Flight Procedures Cover Page	Task Action: FLIGHT CHECK	Task Type: IAP	Estimated Chart Date: 03/19/2026	APWS Task ID: 27DE532606074CC2AAE479132389FE34	APWS Project ID: 00C896C3A8AF44F6BC889E6278105E1A
Procedure: RNAV (RNP) Z RWY 17R AMDT 1		Enroute: NO	Specialist: Hirst, Charles		Agreement Number:
Airport ID: KDEN			Airport City: DENVER		State: CO
Facility ID:	Facility Type:	Flight Inspection Remark Type: New FC Slot

SUBJECT: APPROVAL: DENVER, CO KDEN RNAV (RNP) Z RWY 17R

ISSUE: MANDATORY ALTITUDE RESTRICTION: INTERMEDIATE SEGMENT QWIKE TO STAAM

RNAV (RNP) Z RWY 17R

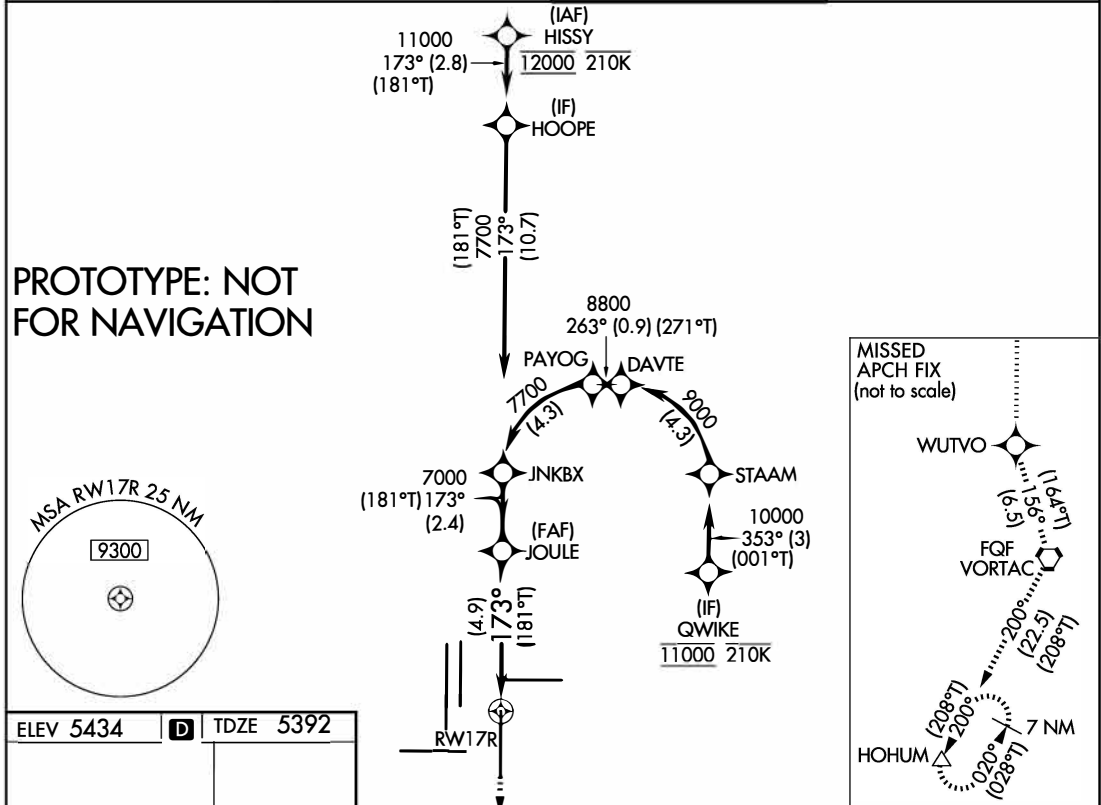
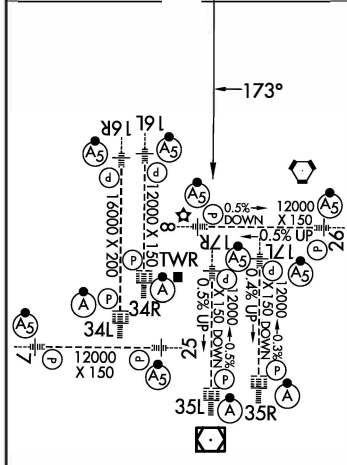
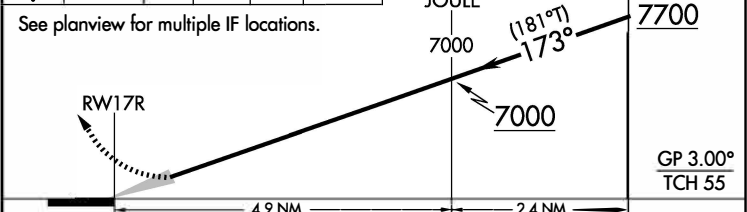
ADD INITIAL FIX HISSY. REDESIGN MISSED APPROACH.

1. NOTES REMOVED "CHART NOTE: USE OF FD OR AP PROVIDING RNAV TRACK GUIDANCE REQUIRED DURING SIMULTANEOUS OPERATIONS."

2. CHANGED PBN REQUIREMENTS NOTE FROM "RNP AR APCH - GPS. AUTHORIZATION REQUIRED. FROM QWIKE: RF" TO "RNP AR APCH - GPS. AUTHORIZATION REQUIRED. FROM STAAM OR PAYOG: RF."

The intermediate segment for the RNAV (RNP) Z RWY 17R QWIKE to STAAM has a mandatory altitude of 11000 MSL. The following four STARS that service KDEN have a mandatory altitude of 11000 MSL at QWIKE: CLASH ARRIVAL, NIIXX ARRIVAL, TBARR ARRIVAL and SSKII ARRIVAL.

Requesting approval to continue to publish the mandatory altitude restriction at the intermediate fix QWIKE IAW the 8260.3G 2-2-7f criteria. It is not possible to easily convert QWIKE to an initial fix without significant redesign of the subsequent segment due to leg length and TF to RF requirements.
